UNITED STATES PATENT AND TRADEMARK OFFICE

APPLICATION NO.	FILING DATE	FIRST NAMED INVENTOR	ATTORNEY DOCKET NO.	CONFIRMATION NO.
10/560,244	12/12/2005	Toshiaki Kashihara	Q91286	4994
23373 7590 04/06/2009 SUGHRUE MION, PLLC 2100 PENNSYLVANIA AVENUE, N.W. SUITE 800 WASHINGTON, DC 20037				
EXAMINER TAMAL, KARL I				
ART UNIT 2834		PAPER NUMBER		
MAIL DATE 04/06/2009		DELIVERY MODE PAPER

Office Action Summary

DETAILED ACTION

Fujita figure 1.

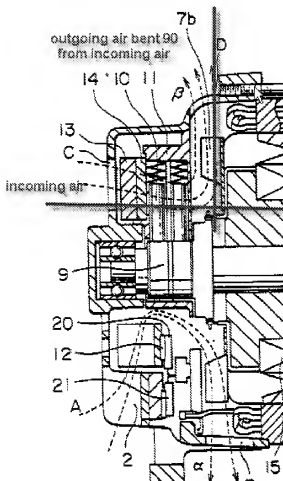
7. Claims 1, 3, 4, and 7 are rejected under 35 U.S.C. 102(b) as being anticipated by Fujita et al. (Fujita)(US 2002/0043886) and Oohashi et al. (Oohashi)(US 2003/0015932). Fujita teaches a generator for a vehicle having a rotor 6 with a field windings 15, a stator including a stator core 17 arranged opposed to the rotor and an electrical conductor wound 18 on the stator core, and a housing 3 supporting the rotor and the stator. Fujita teaches the stator core 17 is constituted by core having a plurality of slots (see figure 3) each extending to an axial direction, the electrical conductor is comprised of a rectangular slot-in portion 18a located in the slots and a circular cross-over portion 18b connecting each of the slot-in portions at the shaft end side of the stator, wherein the conductor 18 is formed so that of-the slot-in portion 18a located in the slots is molded to substantially rectangular (in the press dies 102a, 102b of figure 14) in its cross-sectional profile before it is entered in the slots and the conductor of the cross-over portion 18b is substantially circular in its cross-sectional profile. Fujita teaches longer side portion of the conductor (radial side) of the slot-in portion located in

the slots has an insulation coating of which thickness is smaller than that of insulation coating in the cross-over portion due to the insulating resin coating of embodiment 9 (figure 12). Fujita teaches the longer side being in the radial direction and shorter side in the circumferential direction in order to increase output by reducing the chances of magnet saturation. Fujita teaches the core 17 directly connected to the housing 3 being endbrackets 1, 2 (see figure 1) protecting the conductors. Fujita teaches the blades bending the incoming air at a right angle (see figure 1, as annotated and shown below). Fujita teaches every aspect of the invention except it does not teach the core being laminated. Oohashi teaches the core 11 being laminated for easy insertion of the winding 60 (paragraphs 0035-0036) with a rectangular cross section at the in slot portions 16 and circular cross over portions 17. Oohashi (embodiment 7) teaches the rectangular portions are molded by pressing in a jig, the insulation is compressed to be thinner than the round end sections (shown in figures 23A and 23B). It would have been obvious to a person of ordinary skill in the art at the time of the invention to construct the alternator of Fujita with the stator core being laminated to provide easy assembly with a superior rate of production, as taught by Oohashi.
